From: dane@tnesinc.com
Sent: Monday, June 18, 2018 2:25 PM
To: jmaynard@nescolorado.com
Cc: Marc Whorton; 'Luanne Ducett'
Subject: Timberridge Estates - Revised Drainage Report
Attachments: 173300 FDR.pdf

County Comment Responses (Drainage Report Only)

**PRELIMINARY/FINAL DRAINAGE REPORT
FOR
TIMBERRIDGE ESTATES, PRELIMINARY PLAN
PART OF THE RETREAT AT TIMBERRIDGE
(NORTH OF ARROYA LANE)**

SP-18-002

Basin ID: **Arroya Lane Crossing Sand Creek (2,170 cfs) - 3-6'x12' Conc Box Culverts**

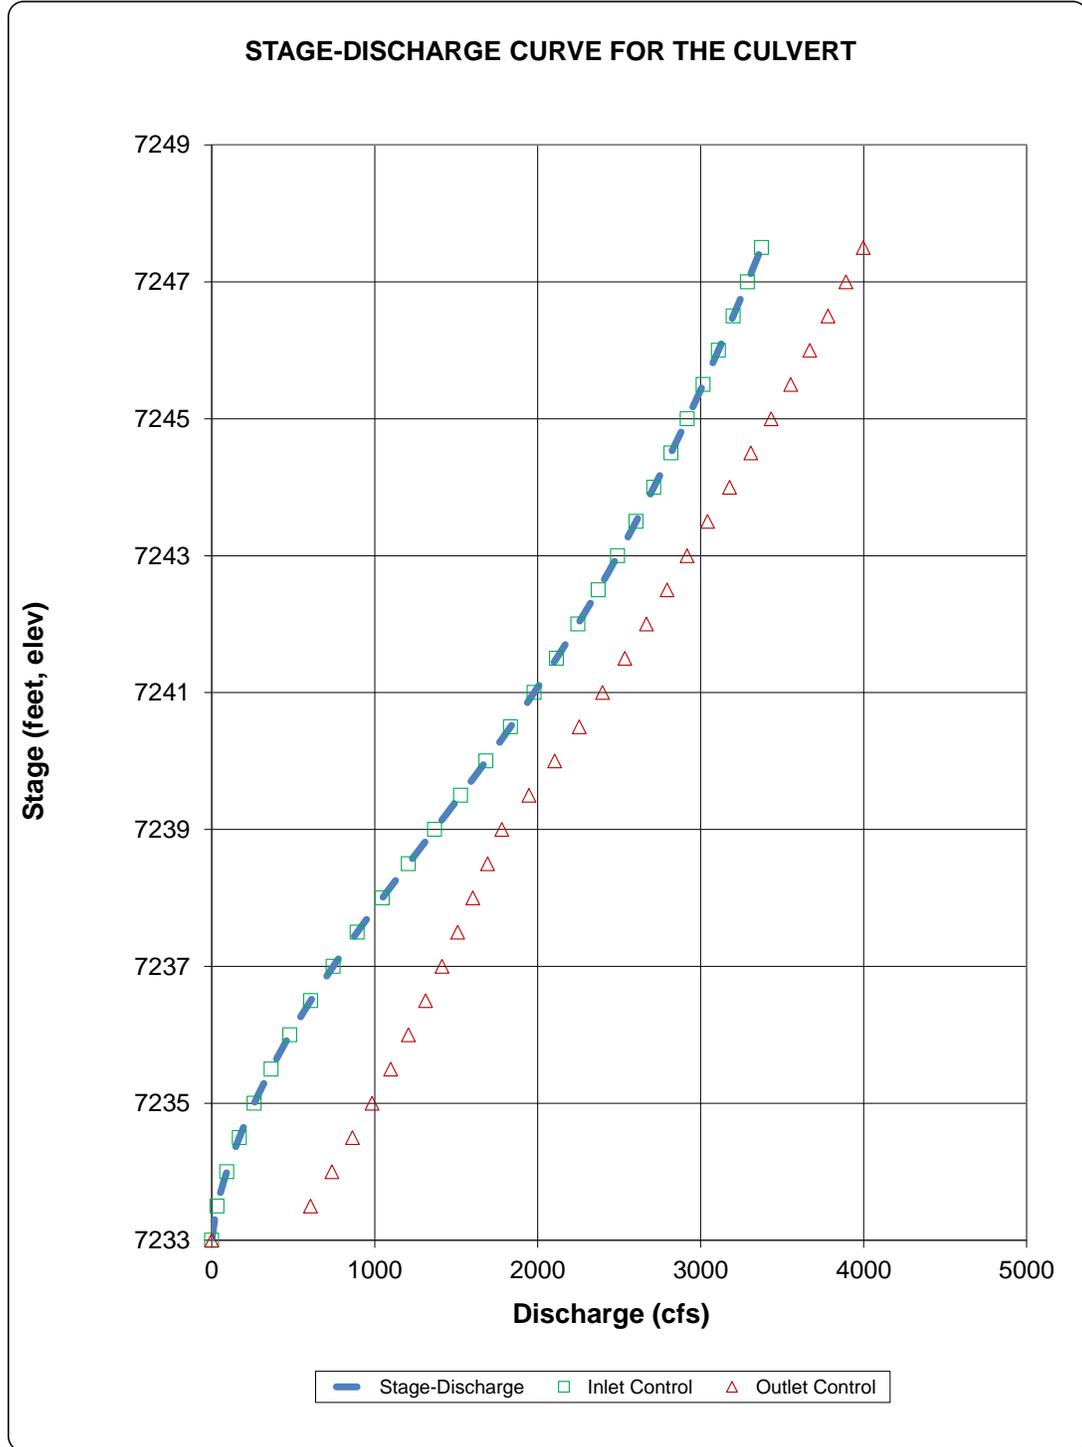
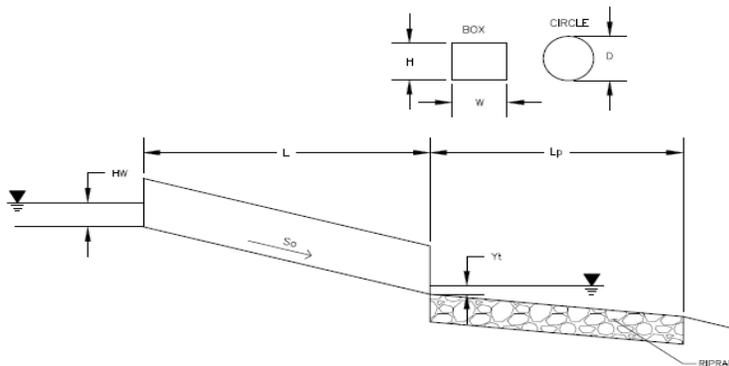
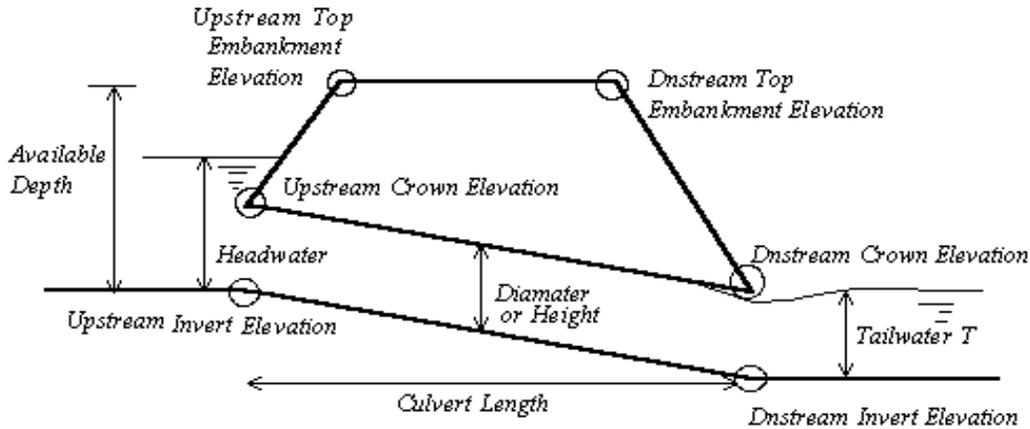
Reference DCM Section 6.4.2. This is a box culvert classified as a bridge. Address freeboard requirements. Provide calcs for FEMA flows unless a LOMR with lower flows has been approved. (Also would be a FEMA floodplain to north if studied.)

TIMBERRIDGE ESTATES EXISTING DRAINAGE PLAN

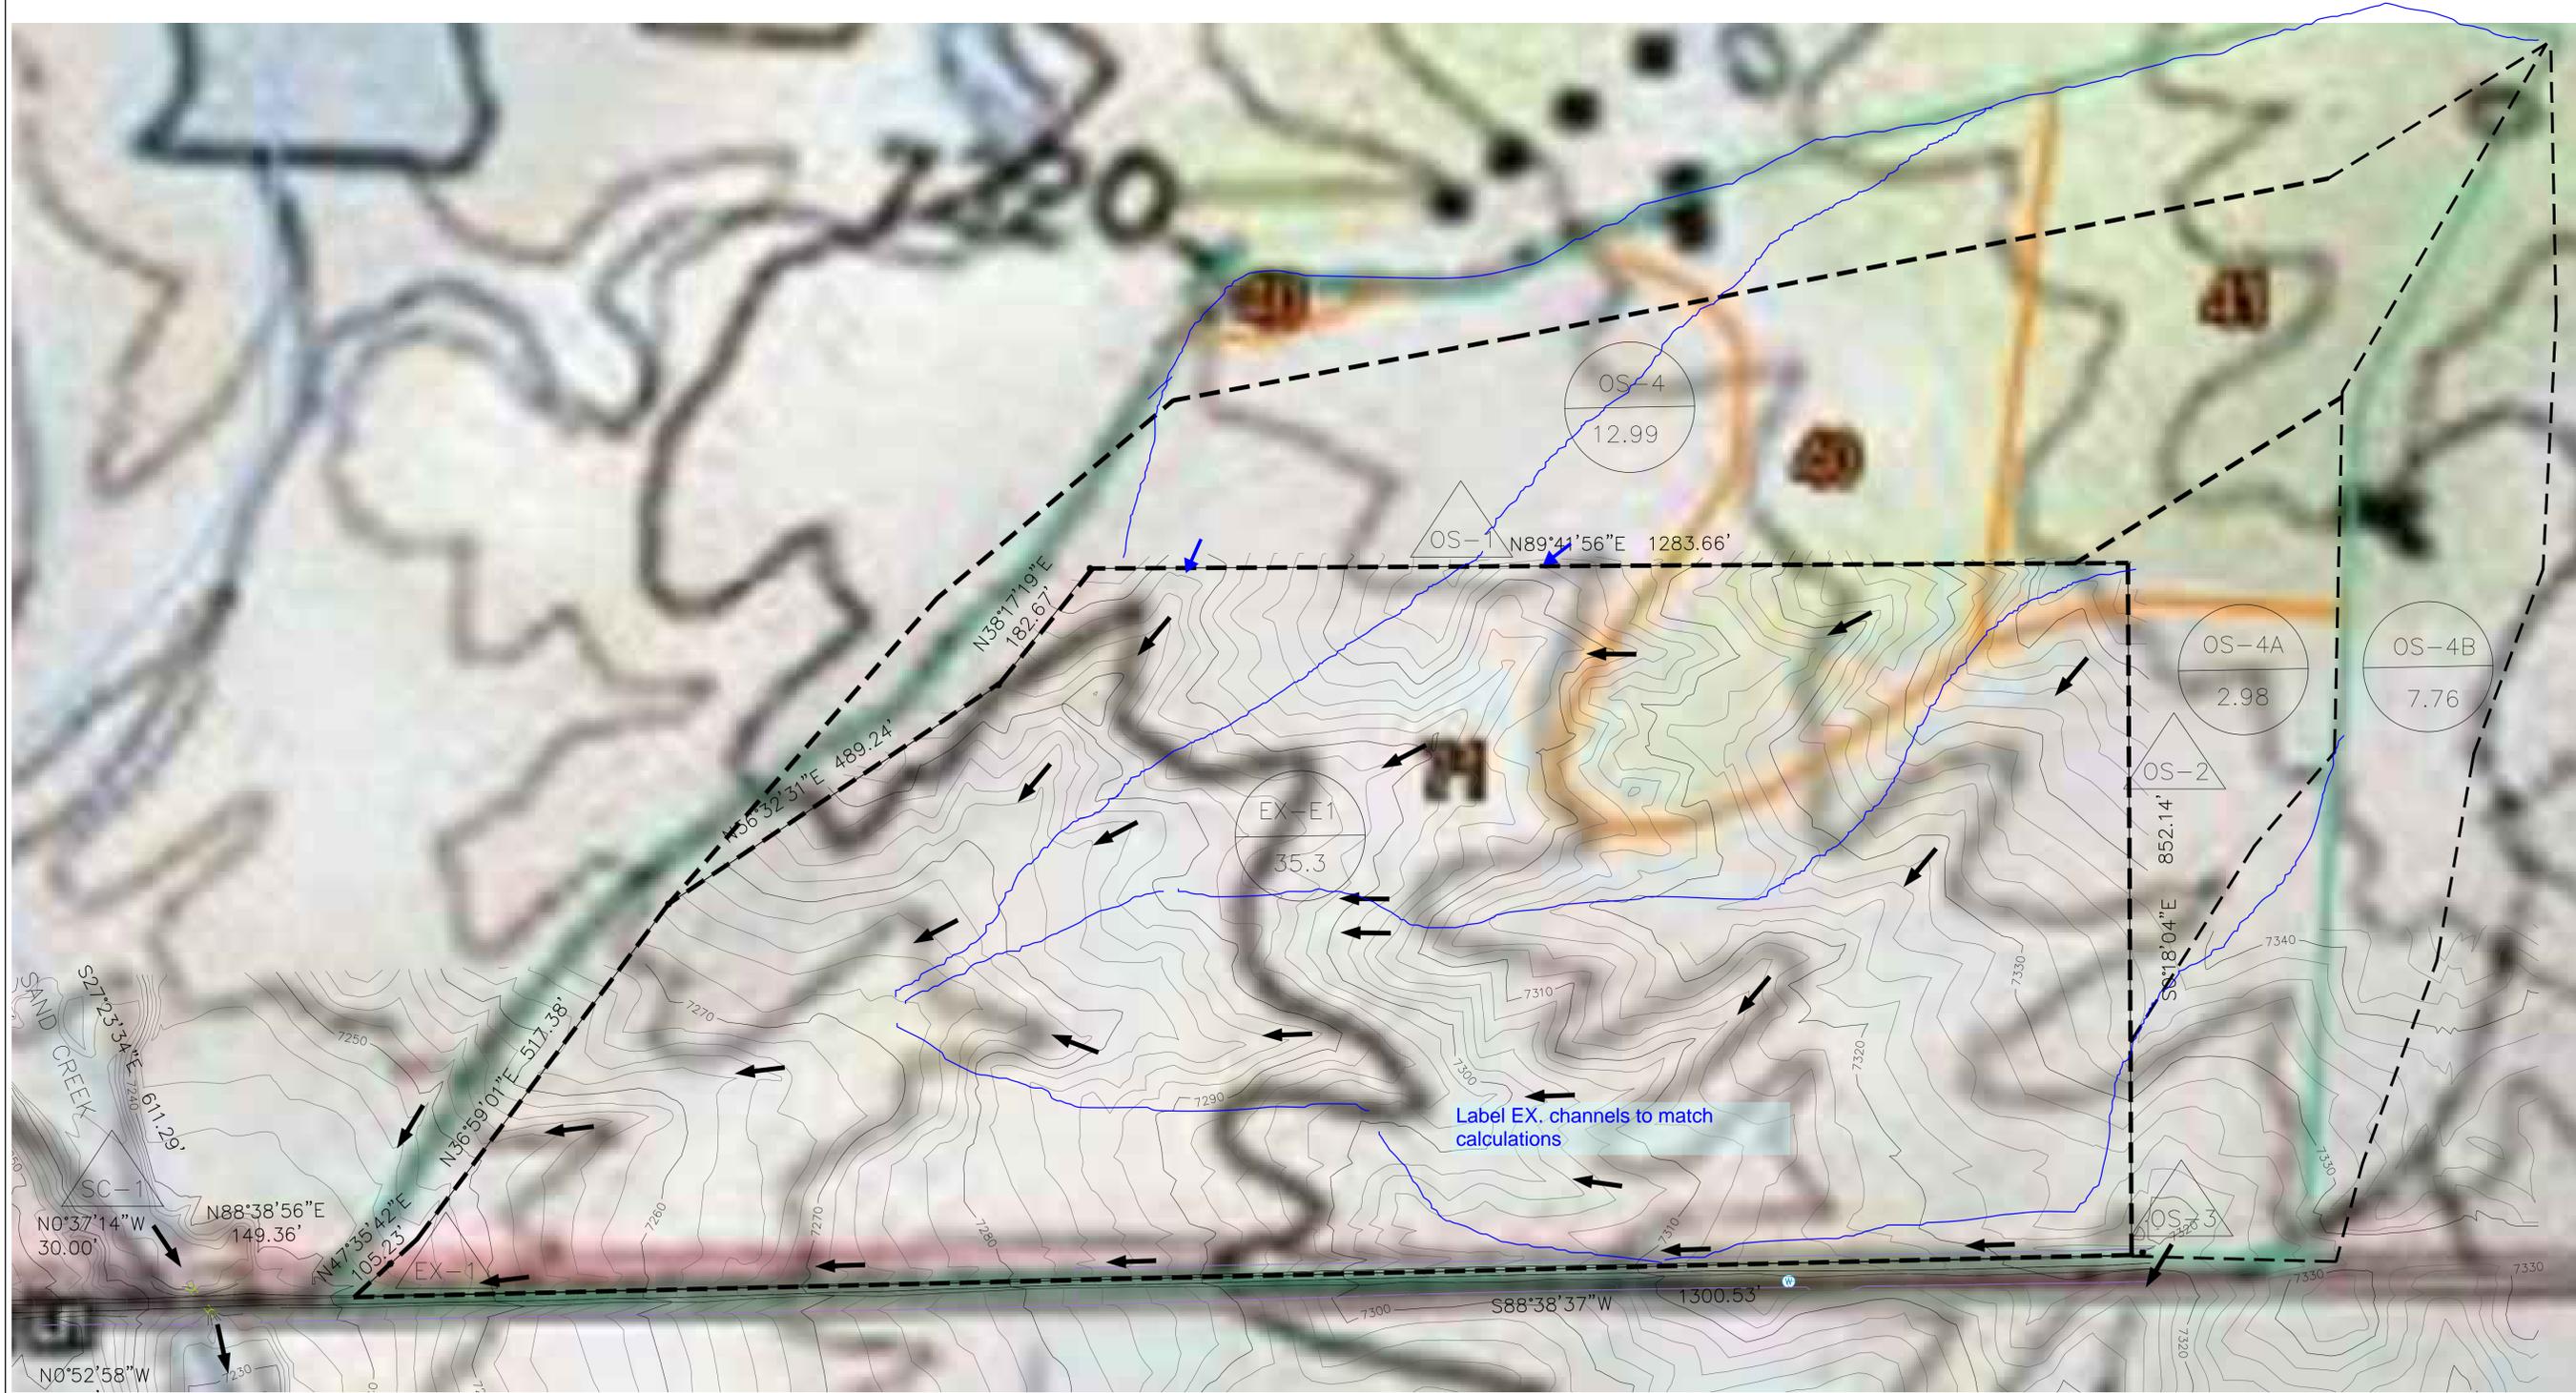
label on existing plan
(all ex. channels)

- Page 4, 2nd paragraph – Q: rural residential? X2, A: Yes to both.
- Page 7, 4th paragraph – Q: HOA or district?, A: District.
- Existing Drainage Plan – Q: What is this line?, A: It is the boundary of a surface feature in CAD, which shouldn't have been shown.

TIMBERRIDGE ESTATES
PROPOSED DRAINAGE PLAN

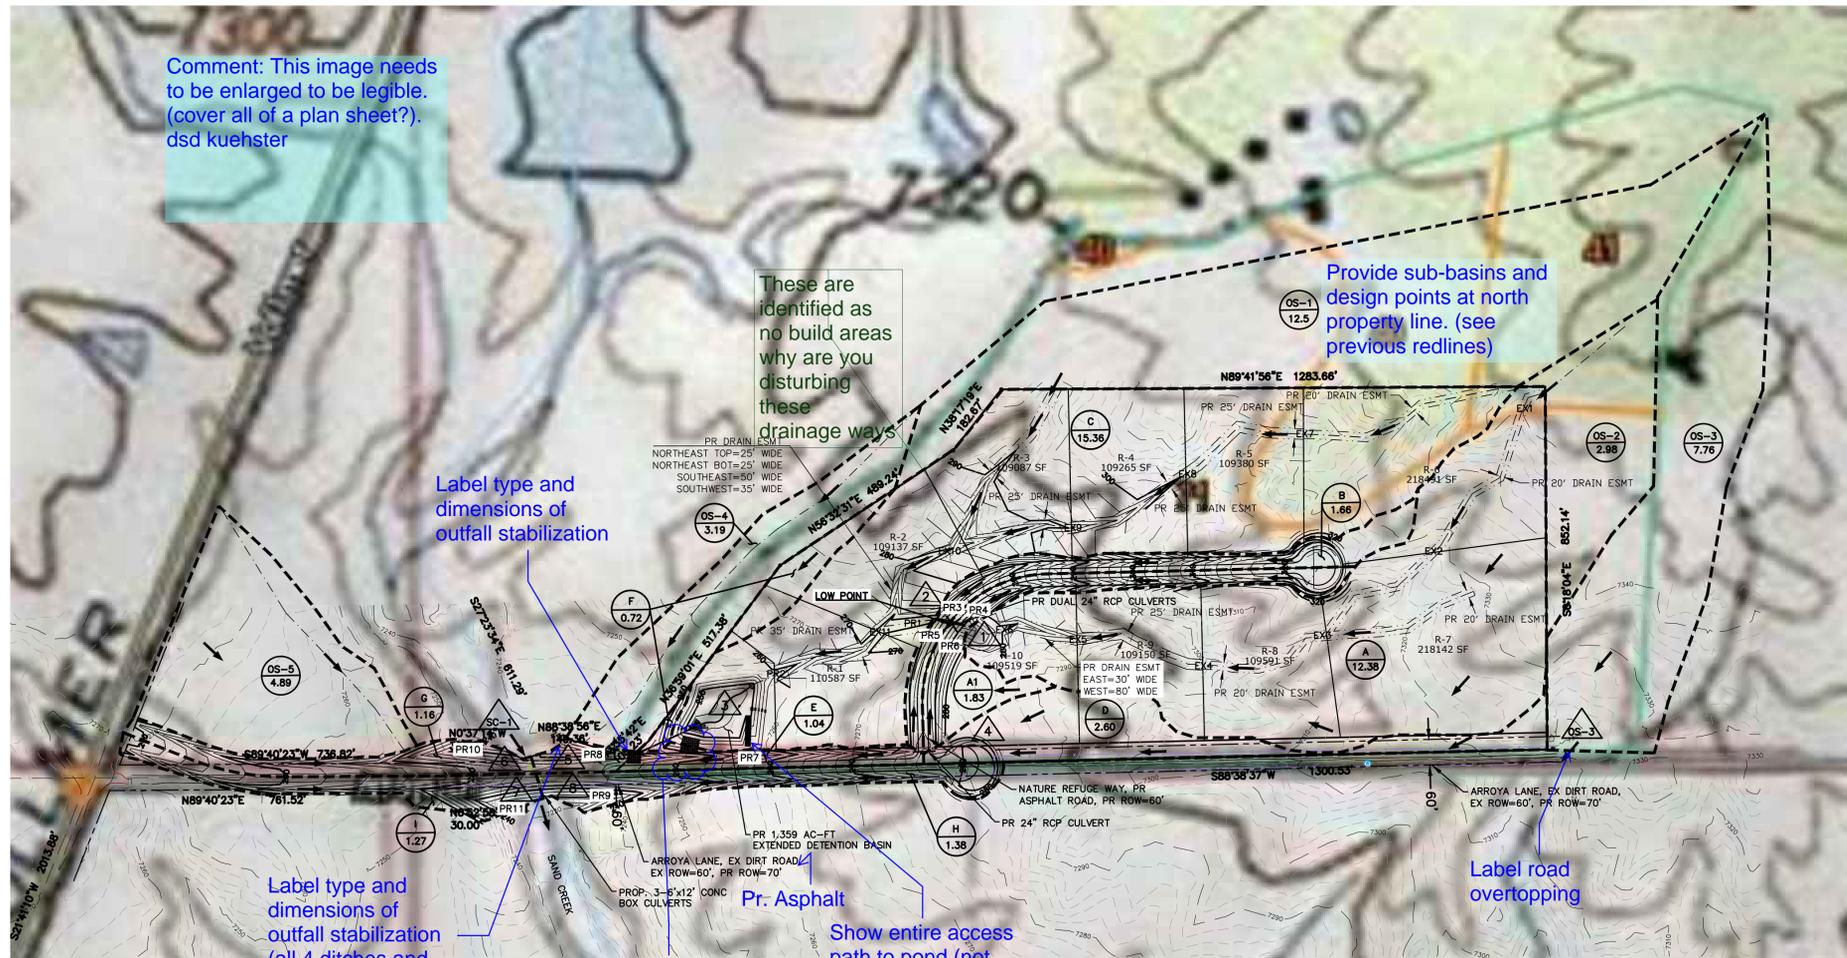
Comment: This image needs to be enlarged to be legible. (cover all of a plan sheet?). dsd kuehster

Provide sub-basins and design points at north property line. (see previous redlines)

Pr. Asphalt Show entire access path to pond (not from Arroya Lane)

- Proposed Drainage Plan – C: Stabilized spillway outfall needs to be entirely within the property., R: It is (shown ending at the property line).

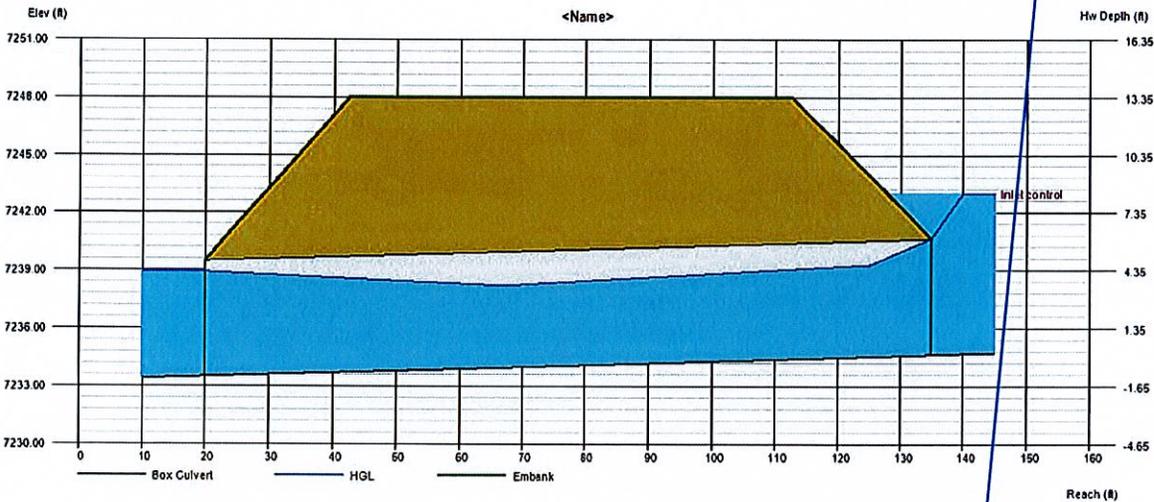
Shouldn't this be 2,600 for FEMA flows?

using ABPS flows
